ADDRESSEES	: Owners and operators ABC Customer Care and parts Source
VEHICLE MODEL	: TD925 and TDX25
MANUAL CHAPTER	: 07.06 Steering system – Front axle steering
BULLETIN TYPE	: Service information
DATE	: July 11 th , 2025
SUBJECT	: Introduction of new components in front axle steering system
TERMS AND CONDITIONS	: This service bulletin does not entitle to any reimbursement.

INTRODUCTION

Figure 1: Front axle steering linkage

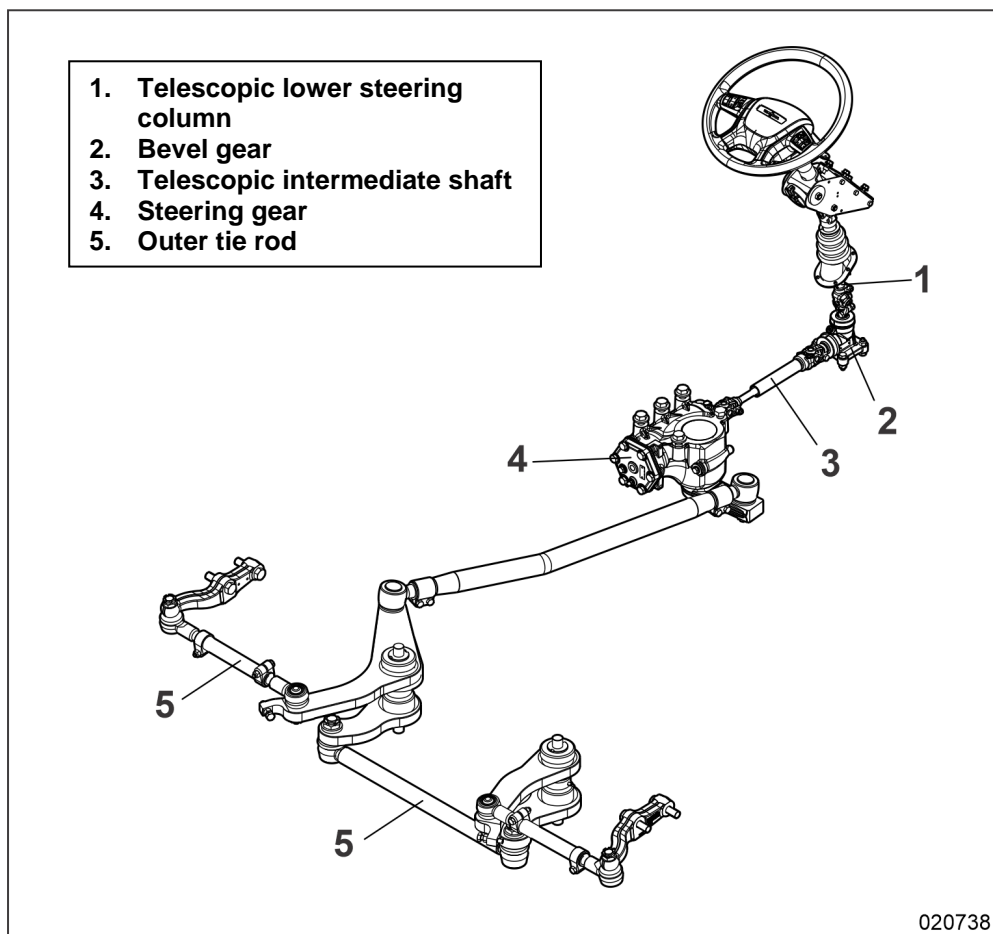
The purpose of this service bulletin is to inform you that VDL Van Hool will switch over to other components for the front axle steering system. This switch-over will be cut into production as from units 89249 (TDX25 Diesel) and 89558 (TDX25 E). Previous references may be used further, but for future orders only the new components will be supplied.

Component	Previous reference	New reference	Remark
Components replaced			
Steering gear	10962967	11921436	Fully interchangeable
Bevel gear	10598332	11921759	Fully interchangeable
Outer tie rod	10861014	11856638	Fully interchangeable
New components			
Telescopic intermediate shaft (between steering gear and bevel gear)	-	11922920	Incorporates two universal joints (one fixed, one removable)
Telescopic lower steering column	-	11502740	Incorporates two universal joints (one fixed, one removable).
Intermediate shaft components which are no longer supported by manufacturer			
Flexible joint (at output side of bevel gear side)	634203950	-	In case replacement is necessary, use telescopic intermediate shaft 11922920.
Fixed intermediate shaft (between steering gear and bevel gear)	10513058	-	In case replacement is necessary, use telescopic intermediate shaft 11922920.
Universal joint (at input side of steering gear)	11554246	-	In case replacement is necessary, use telescopic intermediate shaft 11922920.

Lower steering column components which are no longer supported by manufacturer			
Telescopic lower steering column	11175361	-	In case replacement is necessary, use telescopic intermediate shaft 11502740.
Universal joint (at input side of bevel gear)	11554246	-	In case replacement is necessary, use telescopic intermediate shaft 11502740.
